Access Compliance Report Public Rights-of-Way (Curb Ramps)

Main Street: VAN_BUREN_ST Cross Street: MCFADDEN_AVE Location: NE

ADA ID: RPRK220202115149 Ramp Type: Type 4 - Parallel Initial Pass/Fail: Fail Overall Compliance: No Severity Score: 15

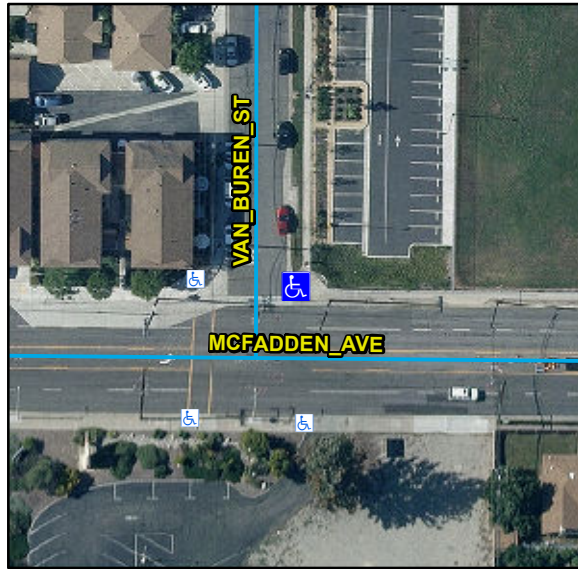
Compliance	Description	Data	Compliance	Description	Data
N/A	Ramp Length LT (in)	64	N/A	Ramp Length RT (in)	91
Yes	Ramp Width LT (in)	118	Yes	Ramp Width RT (in)	119
No	Ramp Run Slope LT (%)	8.7	Yes	Ramp Run Slope RT (%)	5.1
Yes	Ramp Cross Slope LT (%)	1.9	Yes	Ramp Cross Slope RT (%)	1.5
N/A	Landing Present	N/A	N/A	DWS Provided	N/A
N/A	Landing Length (in)	N/A	N/A	DWS Contrast	N/A
N/A	Landing Width (in)	N/A	N/A	DWS Length (in)	N/A
N/A	Landing Run Slope (%)	N/A	N/A	DWS Full Width	N/A
N/A	Landing Cross Slope (%)	N/A		DWS Offset Type	N/A
N/A	Landing Movement Obstructed?	N/A	N/A	DWS Offset Left (in)	N/A
	Landing Movement Type	N/A	N/A	DWS Offset Right (in)	N/A
N/A	Landing Shared	N/A			
N/A	Clear Space	Yes			
N/A	Clear Space To Crosswalk (in)	N/A			
N/A	Marked Crosswalk 1	No	N/A	Marked Crosswalk 2	No
	Crossing 1 Direction	W		Crossing 2 Direction	S
	Marked Crosswalk 1 Width (in)	N/A		Marked Crosswalk 2 Width (in)	N/A

N/A	Ramp Inside Crosswalk 1	N/A	N/A	Ramp Inside Crosswalk 2	N/A
	Crossing 1 Slope (%)	3.6		Crossing 2 Slope (%)	6.7
	Crossing 1 Cross Slope (%)	2.3		Crossing 2 Cross Slope (%)	0.3
N/A	Gutter Ponding	N/A	N/A	Curb Slope	1.6
No	Gutter Lip Height (in)	0.5		Road Run Slope (%)	0.2
N/A	Gutter Run Slope (%)	N/A		Road Cross Slope (%)	1.9
N/A	Gutter Cross Slope (%)	N/A	Yes	Perpendicular Joint Present	Yes
Yes	Overall Surface Condition	Acceptable			
	Cross Gutter Present?	Yes		Spandrel Present?	Yes
	Replace Cross Gutter?	No		Replace Spandrel?	No

Remove & Replace Curb Ramp With Two New Directional Ramps or Equivalent. Grind Gutter Lip.
